SERVICE LETTER

No. 716

Subject: Cross Shaft Support Tube Moisture Seal -- reference attached Avco Lycoming Service Bulletin No. 375A, dated May 10, 1974.

Service Bulletin No. 375A
(Supersedes Service Bulletin No. 375)
Engineering Aspects are
FAA (DEER) Approved

Cross Shaft Support Tube Showing Heat Shrinkable Sleeve Installed

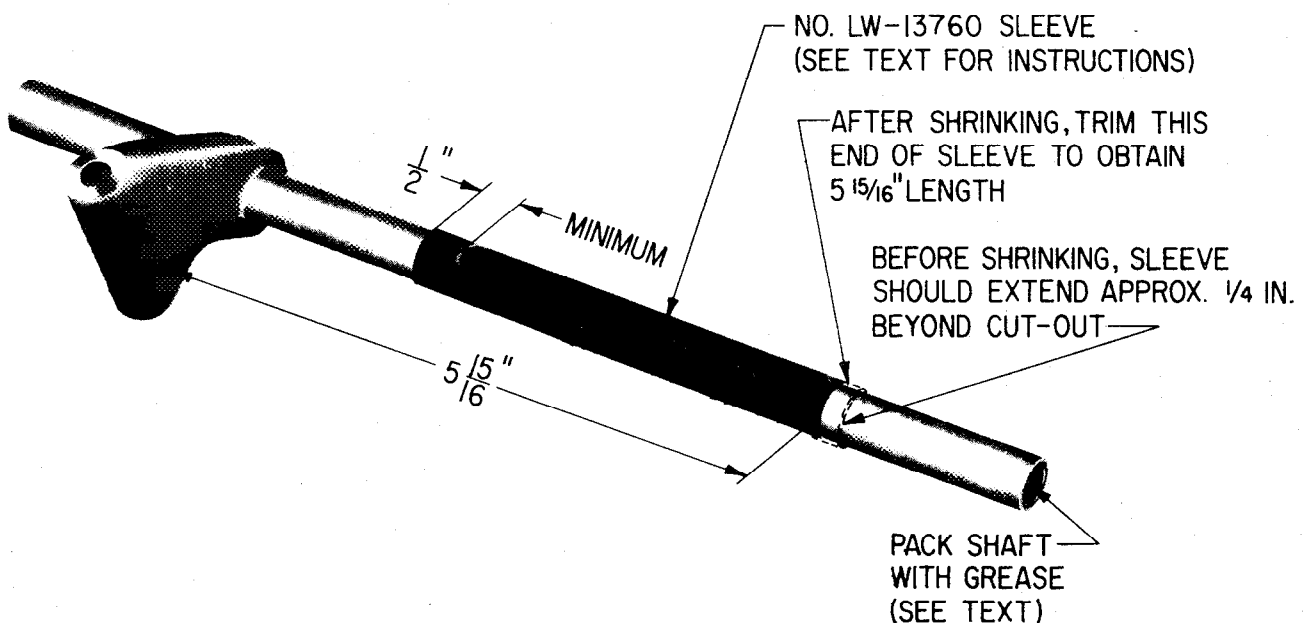
The cut-away portion of the cross shaft control support tube allows moisture to accumulate in the tube causing the fuel injector linkage shaft to freeze inside the cross shaft control support tube. To remedy this situation a heat shrinkable sleeve may be installed over the cut-away portion of the cross shaft control support tube in the following manner.

10. Slip heat shrinkable sleeve LW-13760 over cross shaft control support tube and position over cut-away portion allowing approximately 1/4 inch of the sleeve to extend beyond the slot as shown in the illustration.

11. Using an adequate heat lamp (approximately 375 watts) shrink the tubing on the cross shaft control support tube (using an even heat and rotating motion) until the tubing is tight.

12. Allow the heat shrinkable sleeve to cool on the cross shaft control support tube and trim as shown in figure and assemble cover shaft (right) support.
